Change Proposal

PROJECT: Northeastern Vermont Regional Medical Center
New MRI Addition
St. Johnsbury, VT

CONTRACT NO. 2533
CHANGE PROPOSAL NO. 10
DATE: 6-Aug-19

RE: NVRH MRI Addition – Revised Siemens Drawings Dated 06-17-19

SIEMENS CABINETS CHILLED WATER PIPING DIAGRAM
 N.T.S.

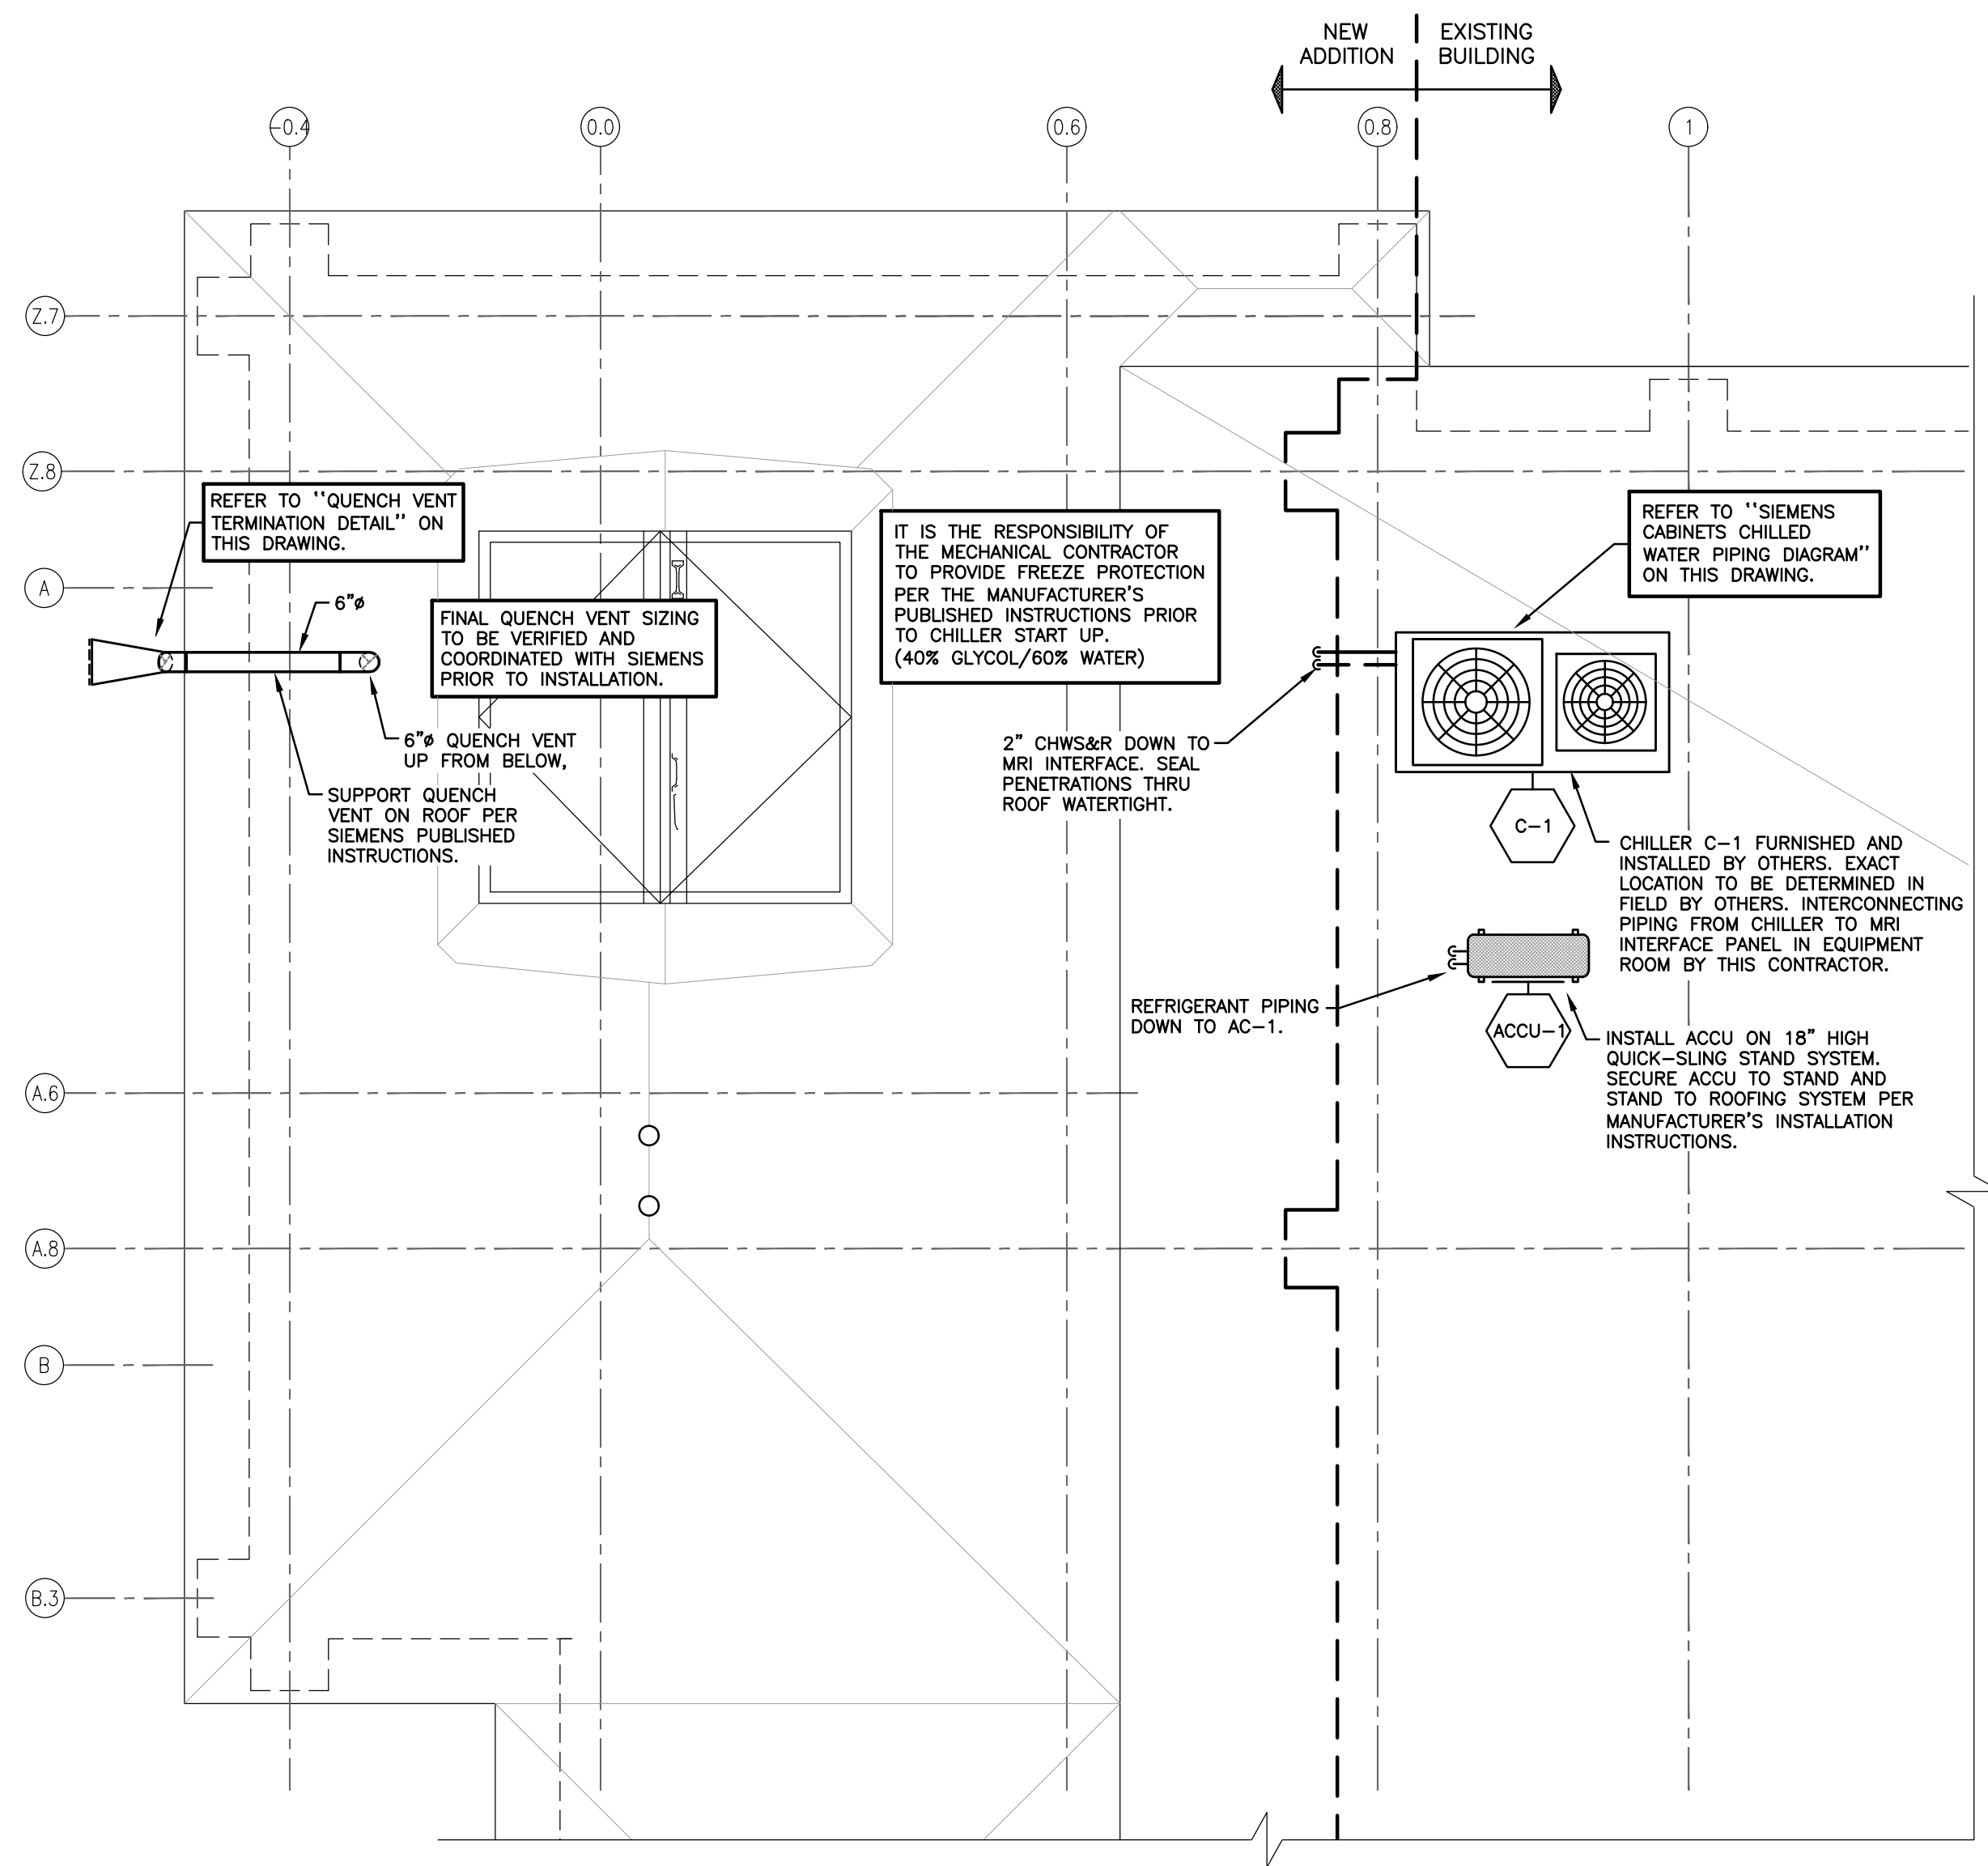
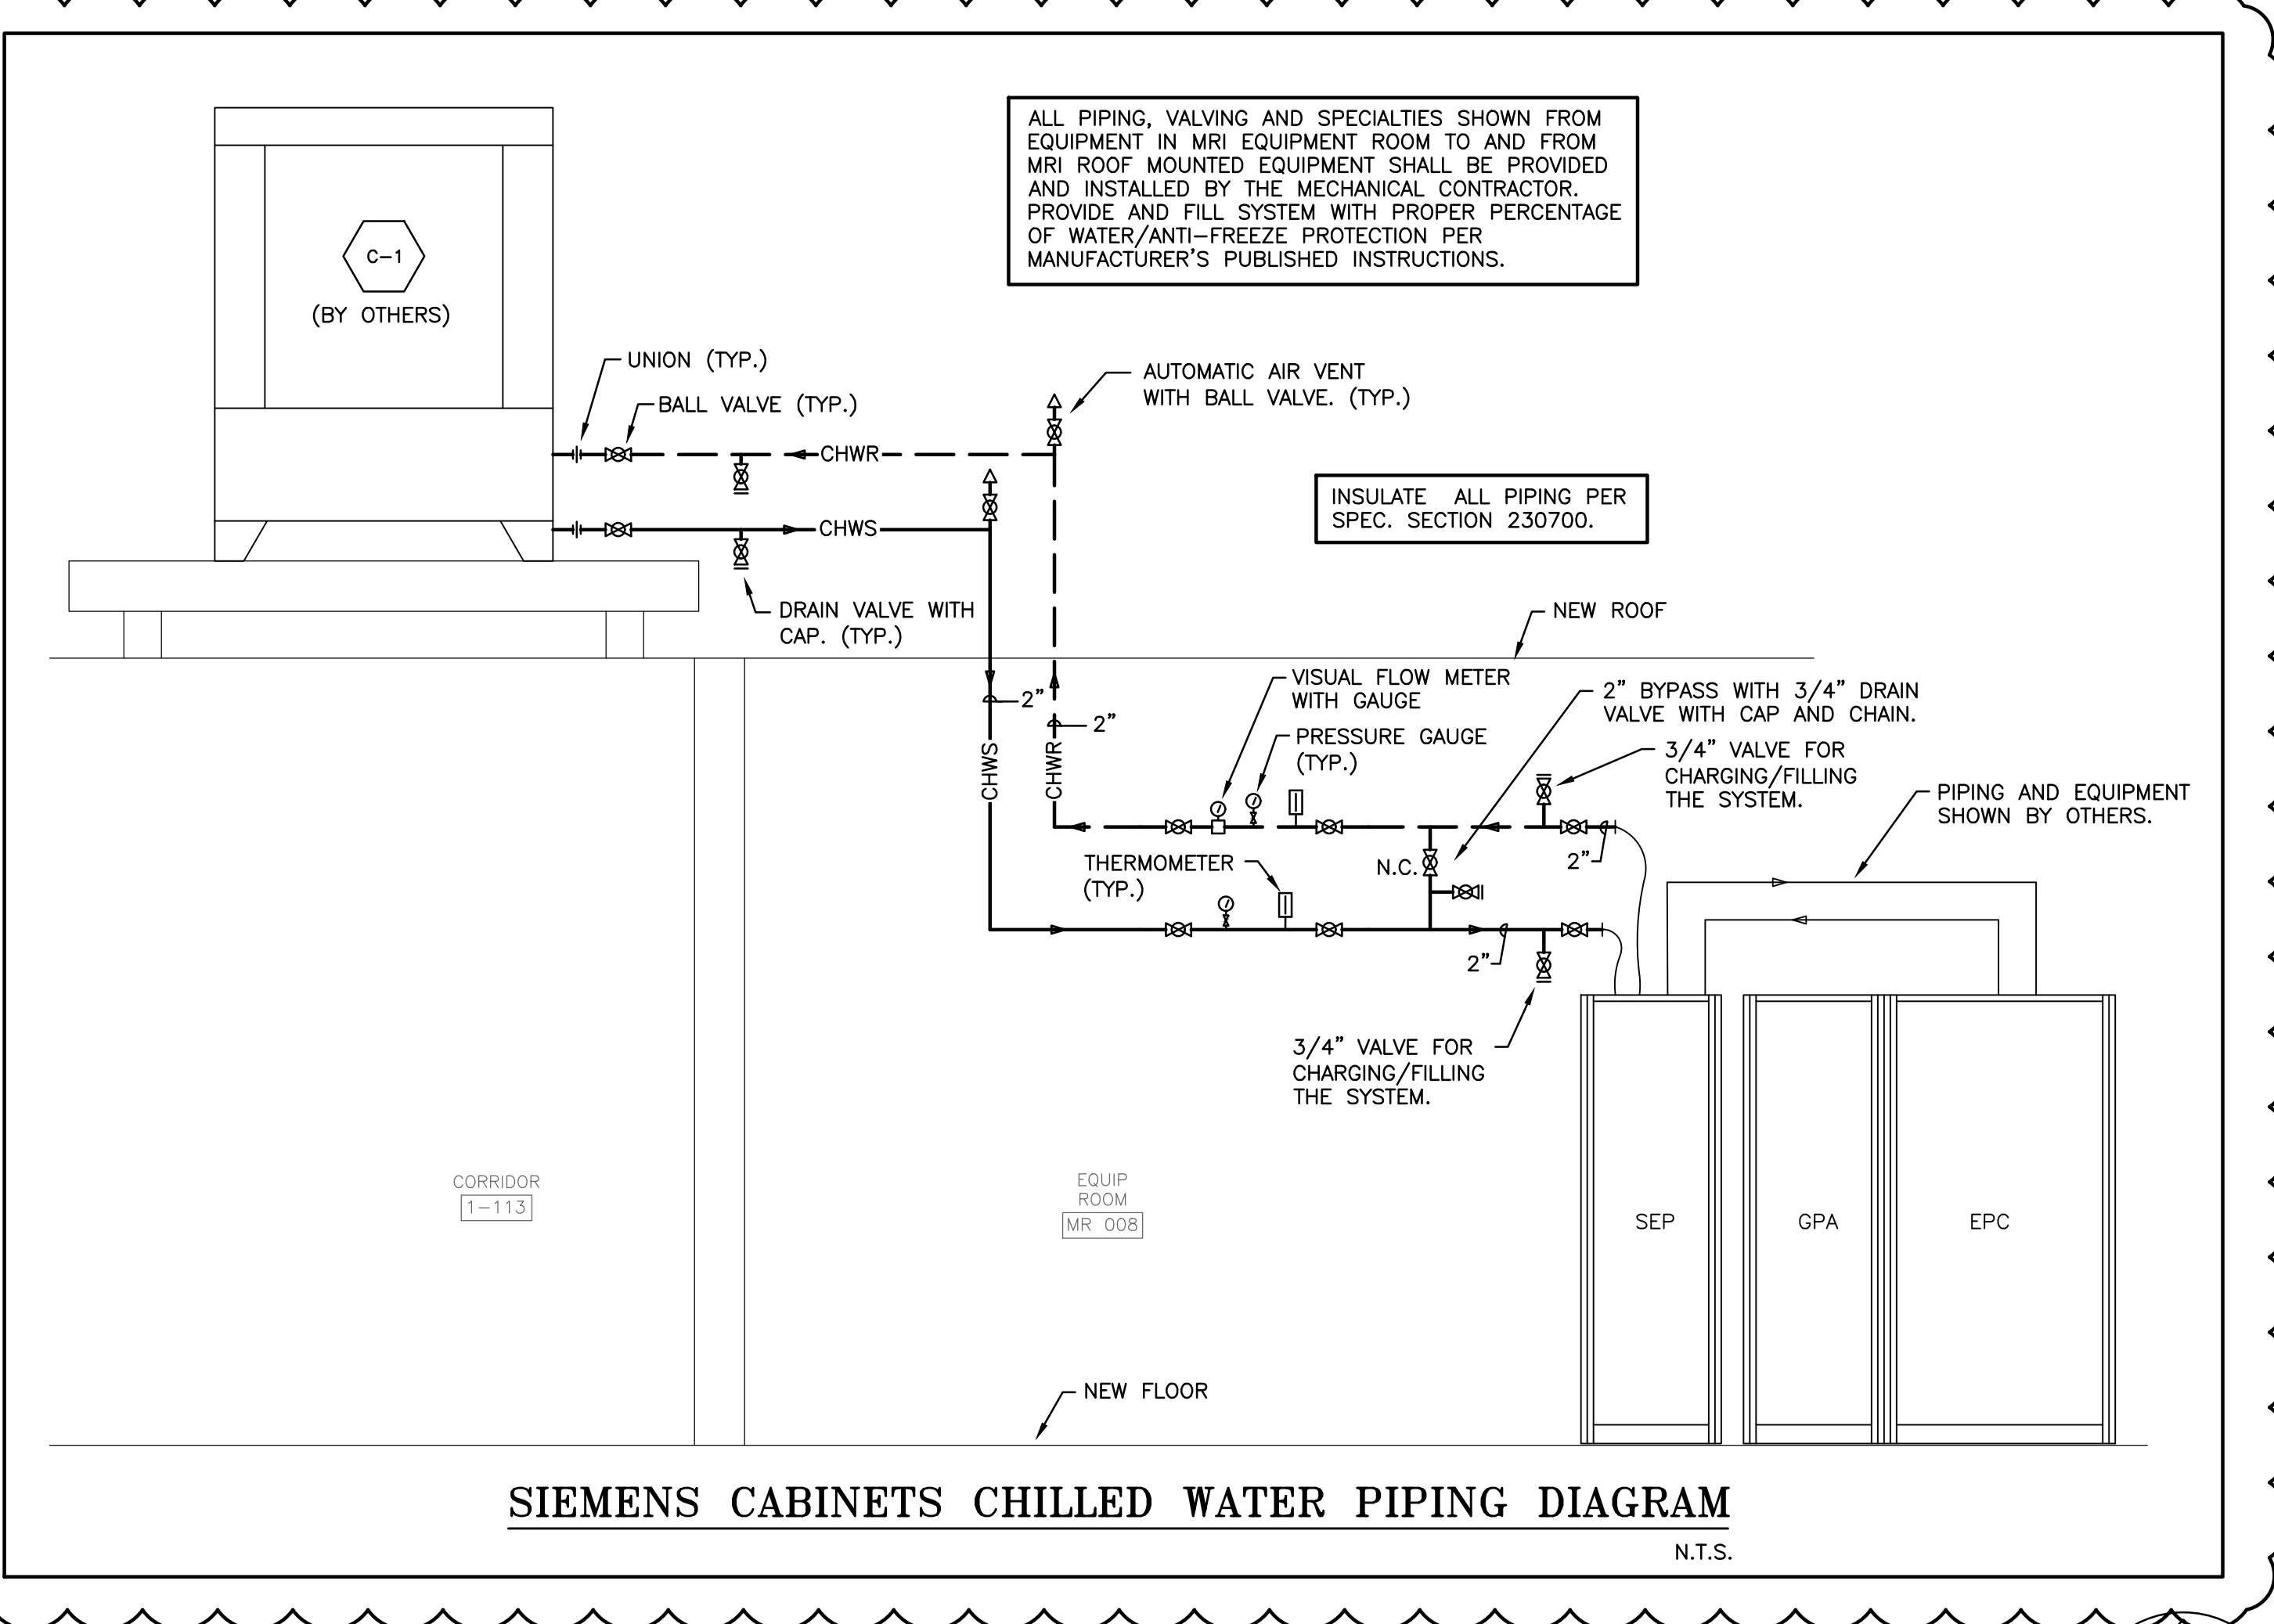
Rev.	Description	By	Date
1	Revised Chilled Water Piping Diagram	BLN	7-9-19

ELECTRICAL RACEWAY PLAN

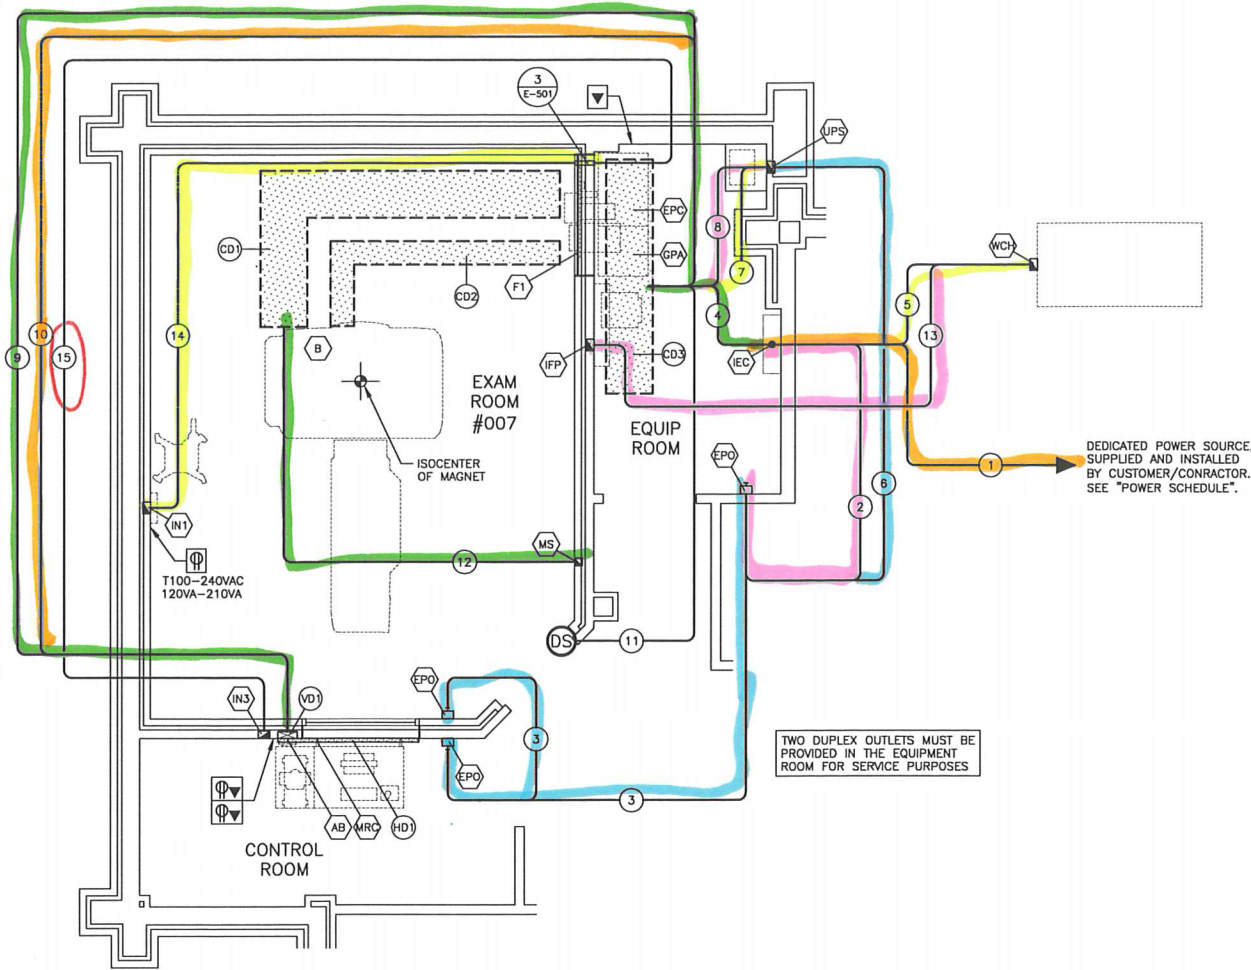
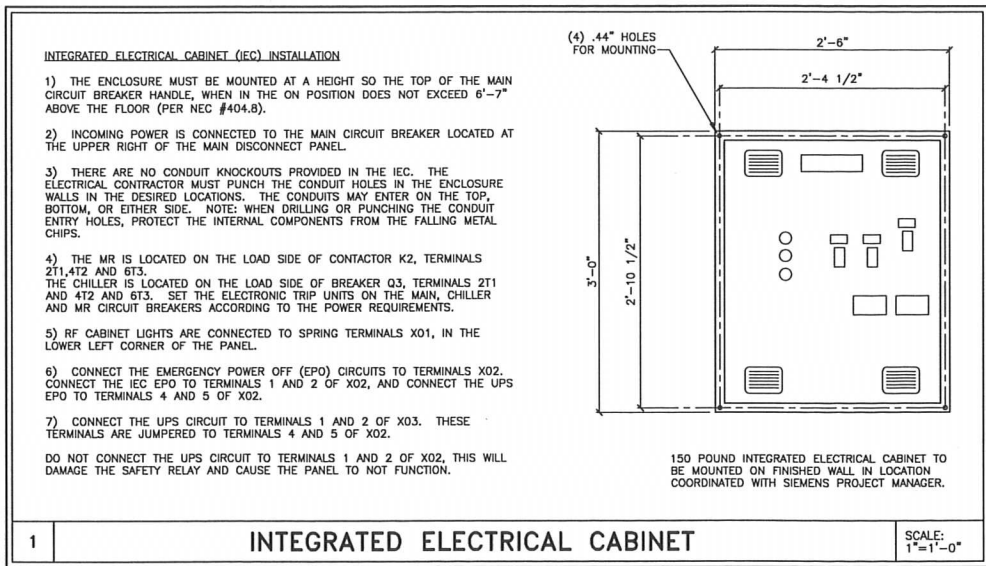
SYMBOL	MAGNETOM SIZE	SOLA SIZE	DESCRIPTION	CHANGE
AB	3"	3"		
EPC; GPA; SEP	18X18	18X18		
B	AS REQ.	AS REQ.		
EPO				
F1				
IFP		N / A		
IEC				
IN1				
IN3				
MRC				
MS				
PS				
WCH				
WCS	N / A	ADDED	PULL BOX MOUNTED FLUSH W/FINISHED WALL	
CD1				
CD2				
CD3				
HD1				
VD1				
1				
2				
3				
4	(1) 2"	(1) 2"		
5	AS REQ.	AS REQ.		
6	(1) 3/4"	(1) 3/4"		
7	(1) 3/4"	(1) 2"		conduit size increase, run change
8	(1) 1"	(2) 2 1/2"		conduit size & quantity increase, run change
9	(2) 2 1/2"	(1) 1 1/2"		conduit size & quantity decrease,
10	(1) 1 1/2"	(1) 1/2"		conduit size decrease, ,run change
11	(1) 1/2"	(1) 3/4"		conduit size increase, run change
12	(1) 3/4"	(1) 1"		conduit size increase, run change
13	(1) 2"	(1) 2"		run change
14	(1) 2"	(1) 2"		run change
15	(1) 2"			deleted
